10595A BOARD EXTENDER KIT**SPECIAL EXTENDER BOARD
P/N 05345-60200 (P/O 10595A)****All Serial Prefixes****COMPATIBILITY WITH 5345A COUNTERS**

PART NUMBER: 05345-90029 (Microfiche Part Number: 05345-90030)

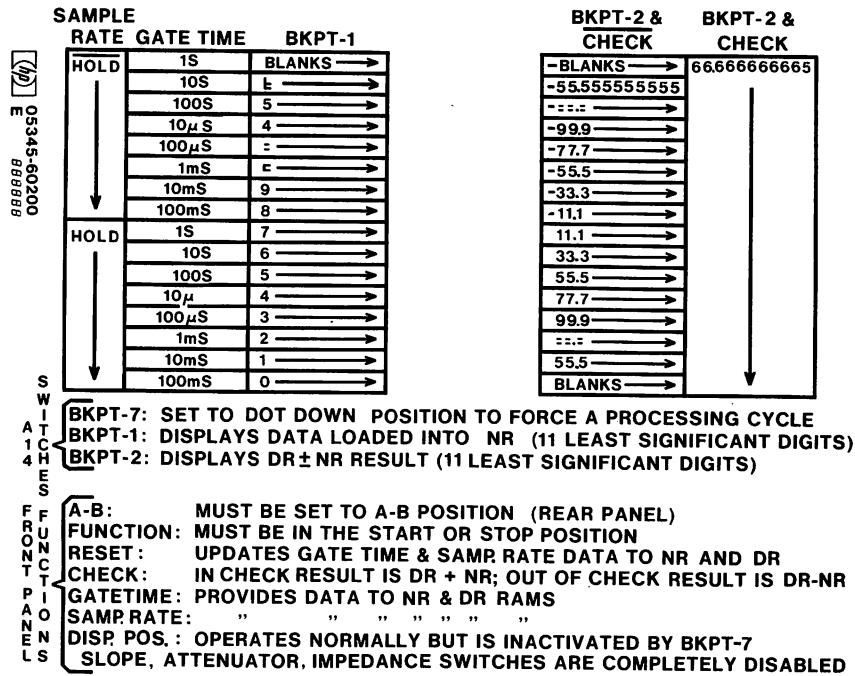
The 10595A Board Extender Kit contains a special test board, P/N 05345-60200. Revisions A through D of this board contain information that applies directly to 5345A Electronic Counters with Serial Prefix 1644A and below (or any 5345A having A14 and A15 board part numbers of 05345-60014 and -60015, or -60034 and -60035). Revision E boards contain information that applies directly to 5345A counters having Serial Prefix 1708A and above (or any 5345A having A14 and A15 board part numbers of 05345-60044 and -60045). These boards are electrically identical. The only difference is in labeling.

Use the following information to allow either of these boards to be used with any 5345A.

Use this information for 5345A counters having Serial Prefix 1708A and above (A14 and A15: -60044 and -60045).

Use this information for 5345A counters having Serial Prefix 1644A and below (A14 and A15: -60014 and -60015, or -60034 and -60035).
